Re: HGY/2024/2584 13 Bedford Road London N22 7AU

Please accept this letter as my objection to the above proposal for planning permission for the *“Demolition of the existing building and the erection of a new mixed-use development up to five storeys high with commercial uses (Use Class E) at ground level, 12no. self-contained flats (Use Class C3) to upper levels and plant room at basement level. Provision of cycle parking, refuse, recycling and storage. Lift overrun, plant enclosure and pv panels at roof level”*.

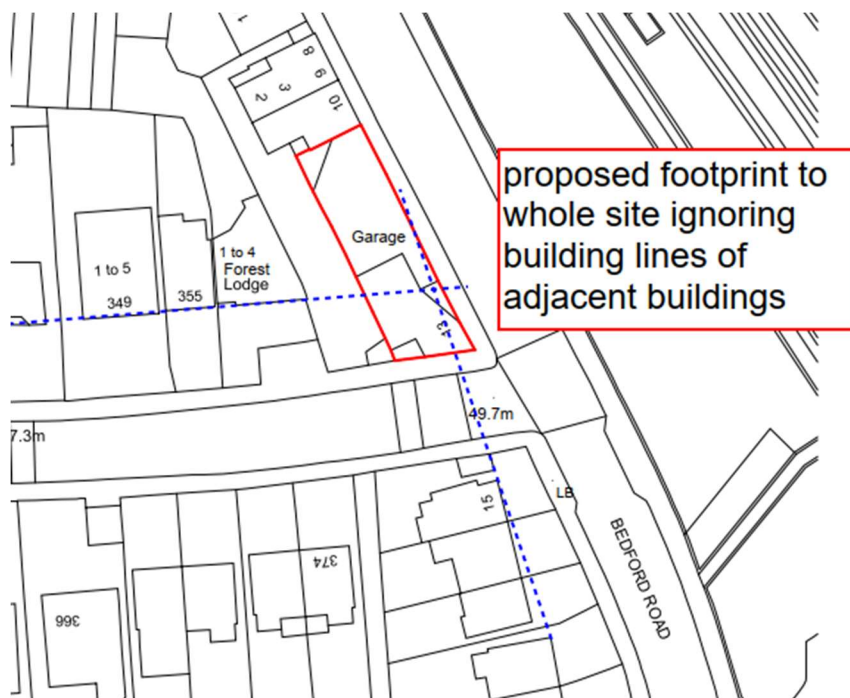
The proposals are taller than its neighbours but the design

- is not of a high standard of architectural quality and design (see comments on elevations below),
- does not include a high quality urban realm, and
- does not improve the nearby Wood Green Common Conservation Area or the approach to the listed Alexandra Palace. The site is visible from both locations contrary to the Heritage Assessment item 31.

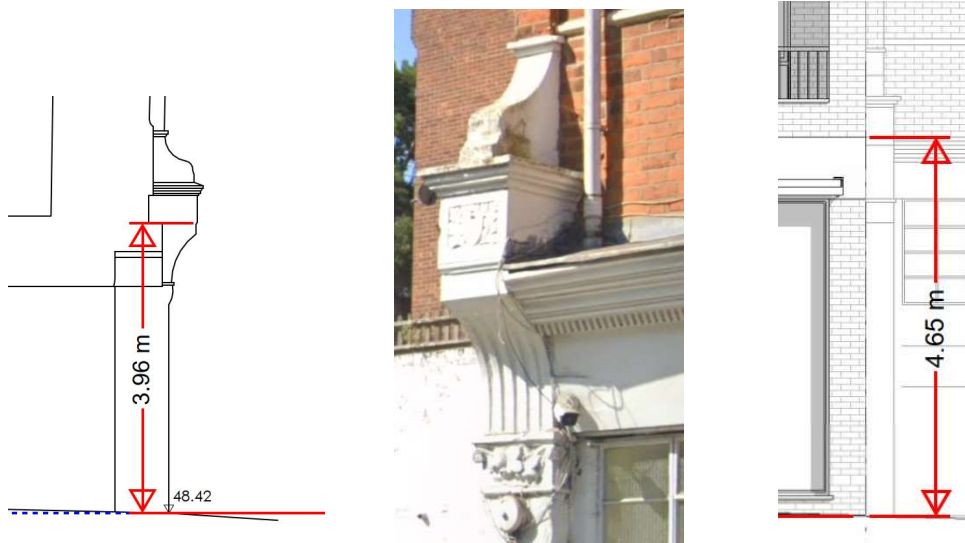
The proposed storey heights for the first floor and above, the parapet line, main roof line and north flank wall do not relate to the neighbouring 10 Bedford Road / Palace Mansions.

The window and balcony treatment of the proposals are unresponsive to the variations in the Bedford Road elevation of 10 Bedford Road which has a clear hierarchy of window forms and reducing storey heights.

The plans do not show a survey of the west or east elevations of 10 Bedford Road / Palace Mansions making it hard to assess alignment heights of elevations. From the surveyed south elevation of 10 Bedford Road the top of the cornice to the shop front is 3.96m above ground but the proposed east

elevation shows it at 4.66m, so the proposed shop front may not align with 10 Bedford Road shop front.

Ref to attached mark-up of drawing 1544-07 Elevations as Proposed.

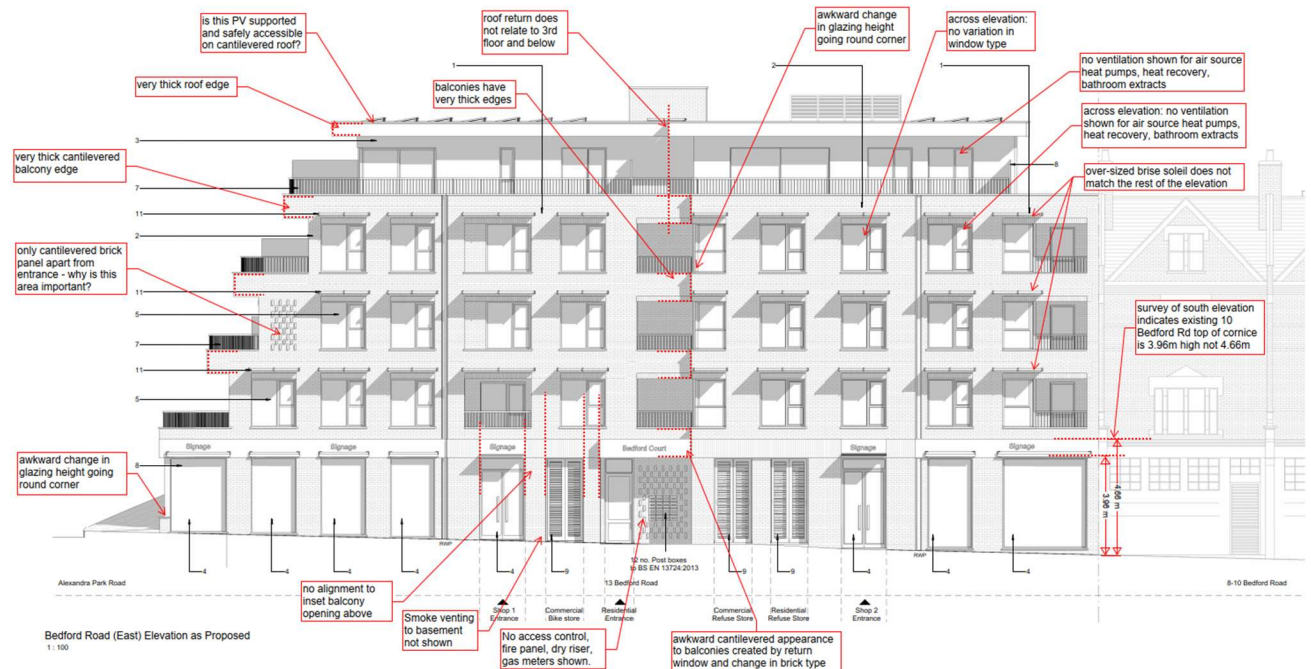
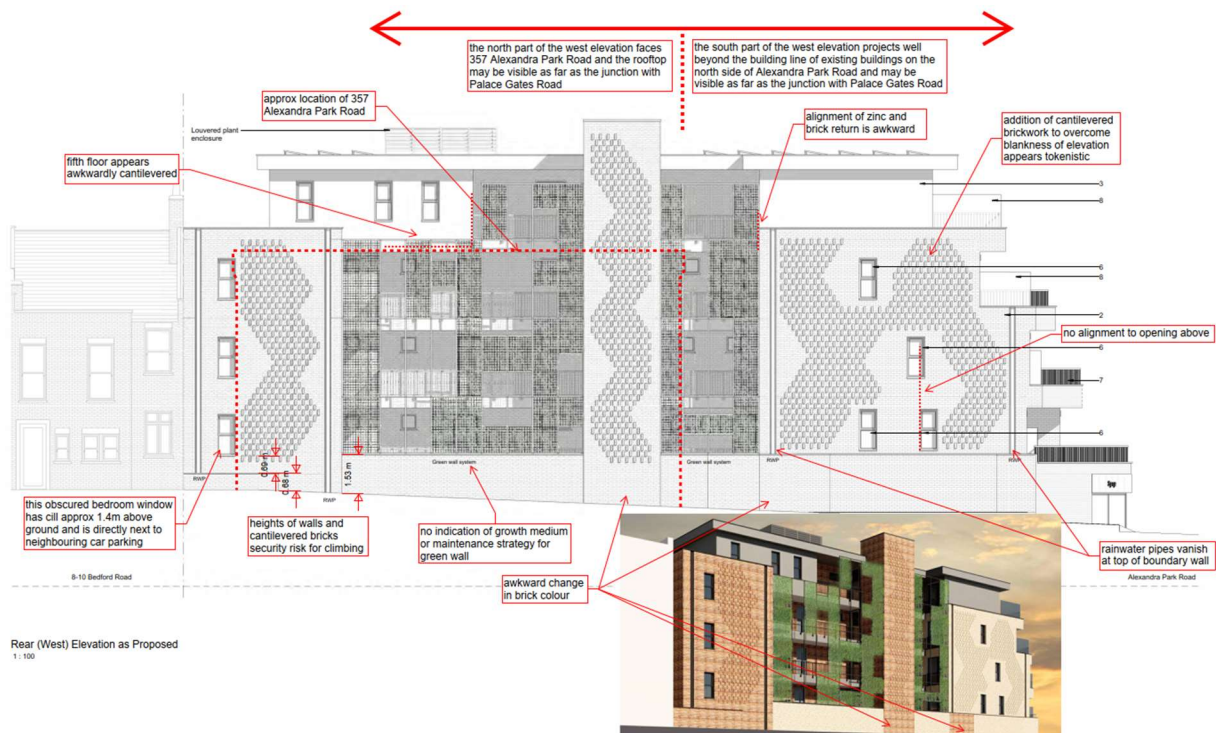
The elevation treatment is not sufficiently considered:

- Window and balcony treatment is undifferentiated, using the same window type and balcony detailing across the east elevation.
- Insufficient definition between yellow & red brick bays e.g. awkward balcony treatment above residential entrance so it looks like southern red brick balconies cantilever towards the yellow brick.
- Lack of hierarchy in façade: steps in plan do not prioritise important elements like entrances to shops to help make a readable façade.
- Inelegant, chunky roof & balcony edges.
- Awkward window returns with differing ground / sill levels e.g. shop front south-east corner and balconies above residential entrance. Awkwardly co-aligned brick and zinc to fifth floor west elevation.

- Multiple vertical misalignments between windows & openings e.g. south shop entrance and windows above.
- Arbitrary inclusion of hit & miss brick cantilever panel at 2nd floor but nowhere else on this elevation main elevation except at the entrance.
- Services not shown adjacent to entrance e.g. access panel, dry riser, gas meters, fire panel.
- Ventilation not shown for heat recovery / air source heat pumps and bathroom / kitchen extracts.
- Not clear how windows will be cleaned with brise soleil in the way.

- Awkward cantilevered appearance to fifth floor north-west corner.
- Addition of cantilevered brickwork to west elevation to mitigate its blank nature appears token and insufficient.

Left: Loss of daylight and sunlight to Win01 & Win03 at 10 Bedford Road / Palace Mansions

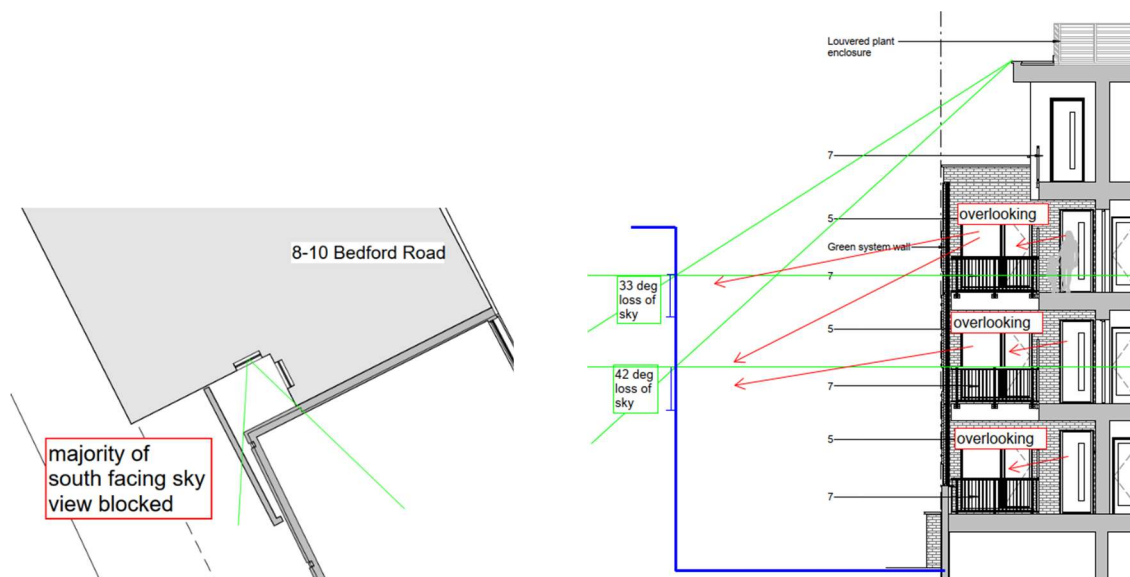
The assessment appears not to have assessed multiple locations on neighbouring properties:

- Vertical Sky Component Daylight Pre development for Win04 & Win09 to 357 Alexandra Park Road missing (p.9, Table 2).
- Report states 10 Bedford Road, Win01 and Win03 meet BRE sunlight guidance but these windows are almost entirely blocked by the proposals (p.11, Table 5).
- Whilst BRE guidance recommends assessment of windows within 90 deg of south (p.10), in this case Win04 & Win09 to east elevation of 357 currently get hours of sunlight in the morning and will be strongly impacted by the proposed development and will certainly not receive >371.5 hrs sunlight post-development (p.12, Table 6).
- Over-shadowing to front garden of 357 Alexandra Park Road not assessed (p.14 Figure 2).

Right: Loss of daylight and sunlight to Win04 & Win09 in 357 Alexandra Park Road:

Below: Overlooking from deck access to balconies to Flats 1, 5, 8 and from balconies and deck access to windows on east elevation of 357 Alexandra Park Road

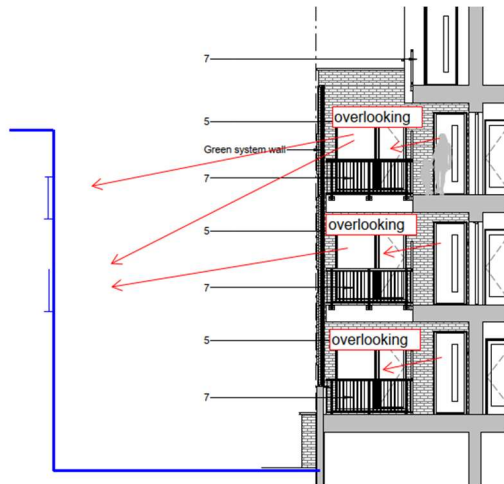
The Community Engagement Report states overlooking has been addressed (p.18) but windows in the proposals (flats 1, 4, 5, 7, 8, 10, 12) and balconies (flats 1, 5, 8) perpendicular to the west site boundary are not obscured leaving views towards bedroom windows in east elevation of 357 Alexandra Park Road (drawings 1544/05, 06). The Planning Statement states that angled views could be controlled by privacy screens (p.14 item 5.25) but this would provide habitable rooms with no view and would have to entirely enclose these balconies. These same balconies are also directly adjacent to deck access making them overlooked within the scheme. The deck access on the west elevation of the proposals also has views towards the same windows in east elevation of 357 Alexandra Park Road.
